REGIONAL REVIEW NOTIFICATION

Name of Proposal: RC-14-02R Willeo Trail Phase IV

Review Type: Metro River

Description: An application for a Metropolitan River Protection Act Certificate for the construction of a boardwalk and pedestrian trail along the Chattahoochee River in the City of Roswell. The majority of the project is in existing right-of-way (Willeo Road), follows old roadbeds, or is within reviewed areas as noted in the application. The project should follow the best management practices described in Appendix A of the National Park Service's Finding of No Significant Impact (FONSI) for the Willeo Road Multi-Use Trail (January 2014).

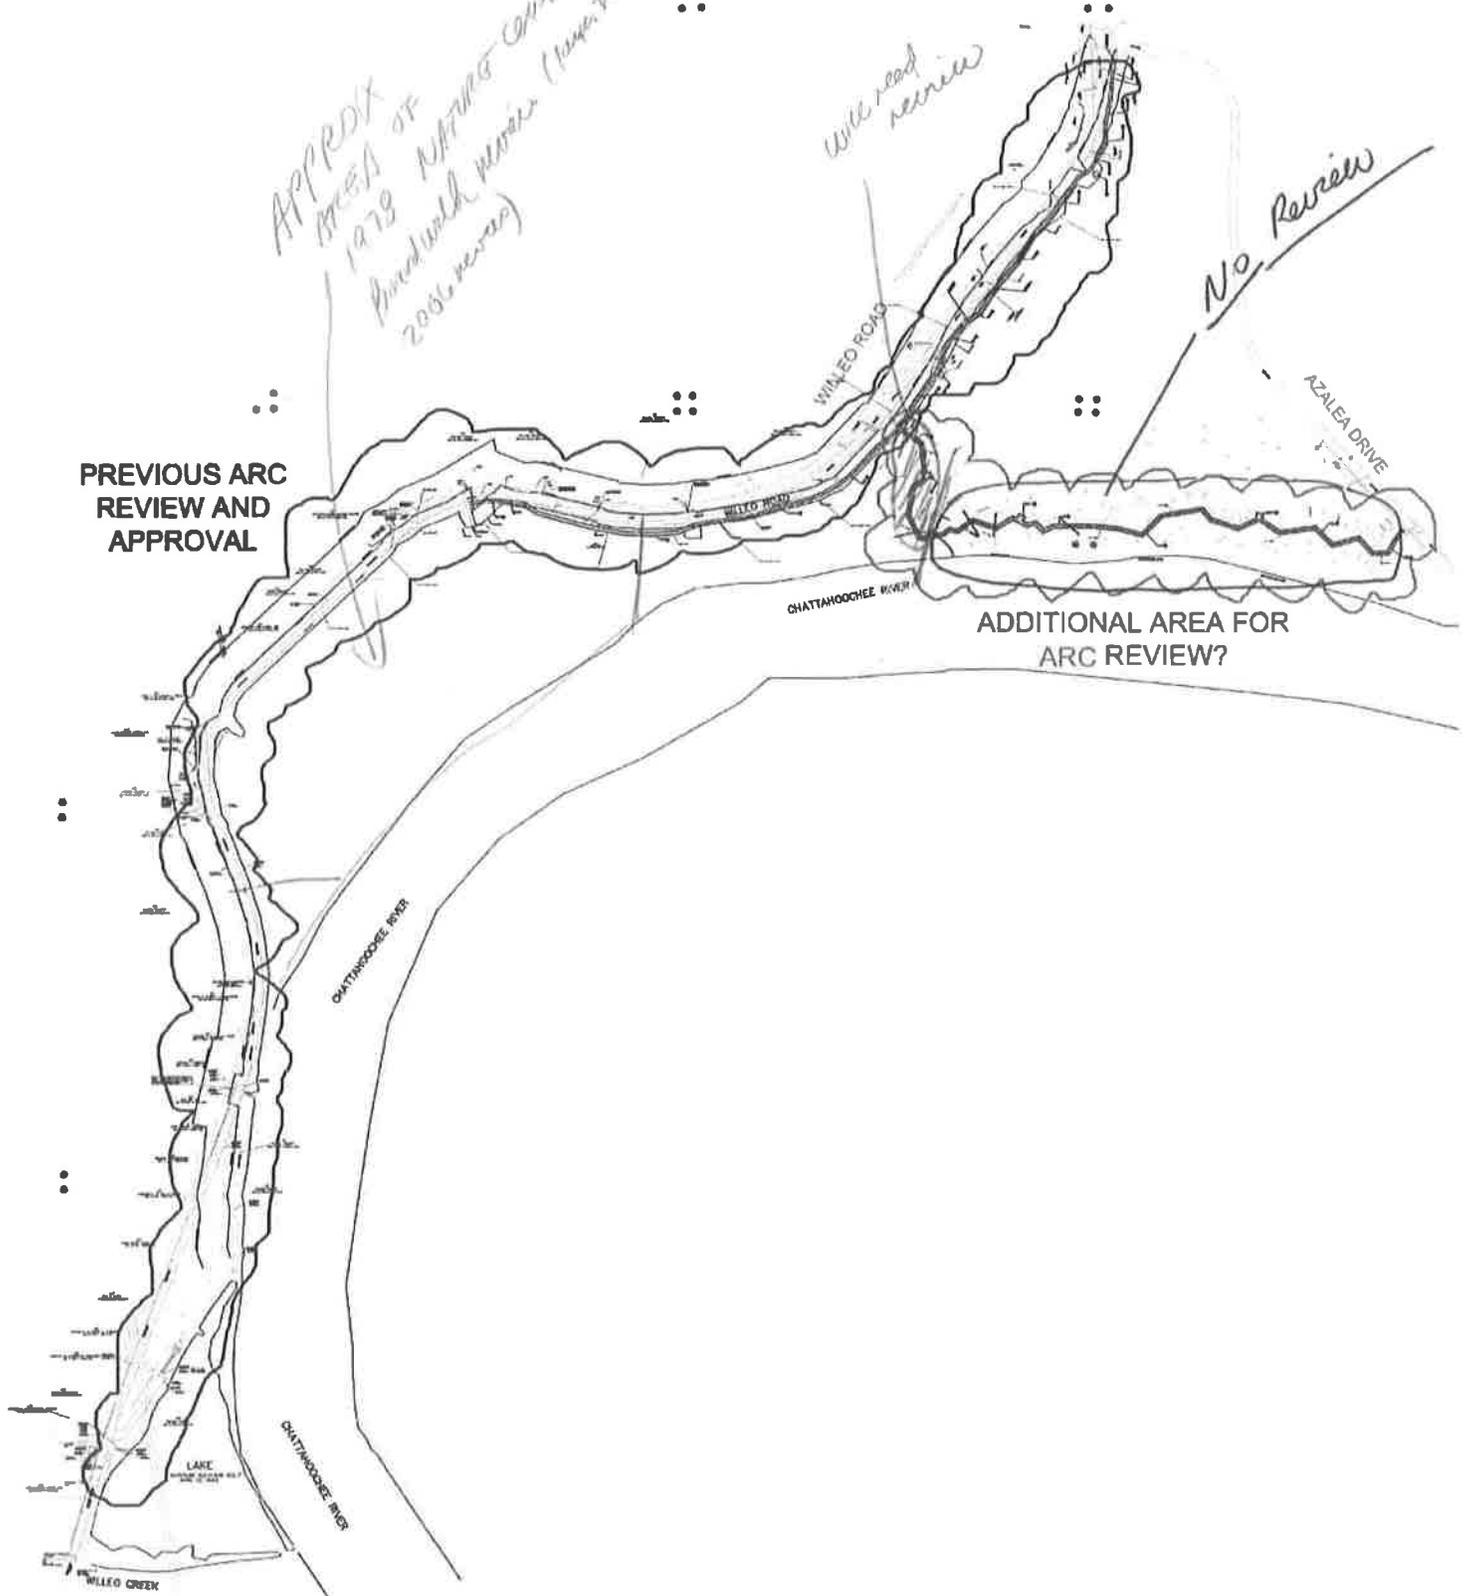
I have looked over our information concerning the existing review status of the proposed Bull Sluice Trail for the section between where it leaves Azalea to where it rejoins Willeo Road. It is my professional opinion that the section of the trail from Azalea Drive to the point where it crosses the channel (or opening) connecting the river to the backwater that is bounded by Azalea and Willeo does **not** require review. I am basing this on the fact that it is still generally following the route of the old farm road that was visible in 1938 aerials found in the research for the first iteration of this project with Pond and company.

However, it is also my opinion that the portion of the trail between the opening and the connection with Willeo will require a Metro River review. I had initially thought that the 1978 review (RC-78-47FC) for the Nature Center Boardwalks included this land. I have checked the review file and it does not. However, this means that all the area from the edge of the review to the open backwater is available for inclusion in the review. I assume it is all floodplain, and therefore all E, so you would need to include enough land so that the land disturbance associated with the property did not exceed 30% of the review area and that the impervious surface did not exceed 15% of the review area.

I am attaching a mark-up of the exhibit Jackie sent to me. It shows the area needing review in red and the area not needing review in blue. I have also indicated my estimate of the boundaries of the 1978 Nature Center review in red.
